Access Compliance Report Public Rights-of-Way (Curb Ramps)

Main Street: HICKORY_BRANCH_RD		Cross Street: COCKSCROW_LN		Location:	E
ADA ID: RPAT211109104921	Ramp Type: Type 4 - Parallel	Initial Pass/Fail: Fail	Overall Compliance: No	Severity Score:	16
Codes/Mitigation Info/Possible Solution			Field Measurements/Component Compliance

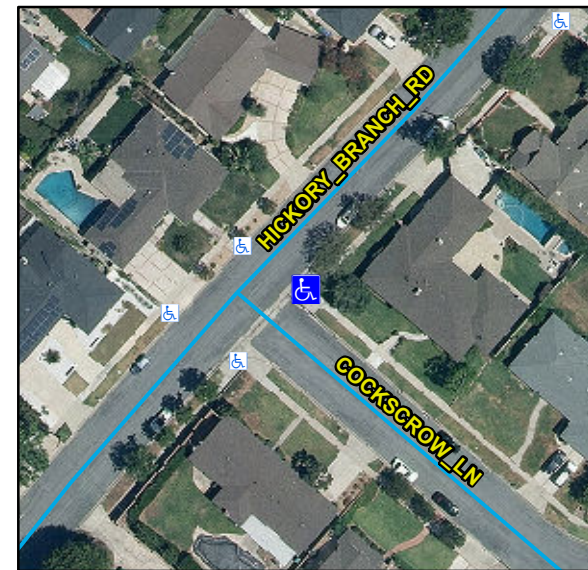
Compliance	Description	Data	Compliance	Description	Data
N/A	Ramp Length LT (in)	108	N/A	Ramp Length RT (in)	107
Yes	Ramp Width LT (in)	65	Yes	Ramp Width RT (in)	78
No	Ramp Run Slope LT (%)	9.2	Yes	Ramp Run Slope RT (%)	6.8
Yes	Ramp Cross Slope LT (%)	0.5	No	Ramp Cross Slope RT (%)	4
N/A	Landing Present	N/A	N/A	DWS Provided	N/A
N/A	Landing Length (in)	N/A	N/A	DWS Contrast	N/A
N/A	Landing Width (in)	N/A	N/A	DWS Length (in)	N/A
N/A	Landing Run Slope (%)	N/A	N/A	DWS Full Width	N/A
N/A	Landing Cross Slope (%)	N/A		DWS Offset Type	N/A
N/A	Landing Movement Obstructed?	N/A	N/A	DWS Offset Left (in)	N/A
	Landing Movement Type	N/A	N/A	DWS Offset Right (in)	N/A
N/A	Landing Shared	N/A			
N/A	Clear Space	Yes			
N/A	Clear Space To Crosswalk (in)	N/A			
N/A	Marked Crosswalk 1	No	N/A	Marked Crosswalk 2	No
	Crossing 1 Direction	NW		Crossing 2 Direction	SW
	Marked Crosswalk 1 Width (in)	N/A		Marked Crosswalk 2 Width (in)	N/A

N/A	Ramp Inside Crosswalk 1	N/A	N/A	Ramp Inside Crosswalk 2	N/A
	Crossing 1 Slope (%)	3.9		Crossing 2 Slope (%)	1.4
	Crossing 1 Cross Slope (%)	5.9		Crossing 2 Cross Slope (%)	1
N/A	Gutter Ponding	N/A	N/A	Curb Slope	6.6
Yes	Gutter Lip Height (in)	0		Road Run Slope (%)	2.5
N/A	Gutter Run Slope (%)	N/A		Road Cross Slope (%)	1.7
N/A	Gutter Cross Slope (%)	N/A	Yes	Perpendicular Joint Present	Yes
Yes	Overall Surface Condition	Acceptable			
	Cross Gutter Present?	Yes		Spandrel Present?	Yes
	Replace Cross Gutter?	No		Replace Spandrel?	No

Remove & Replace Curb Ramp With Two New Directional Ramps or Equivalent.

R304.3.2, R304.5.3, STD 1115
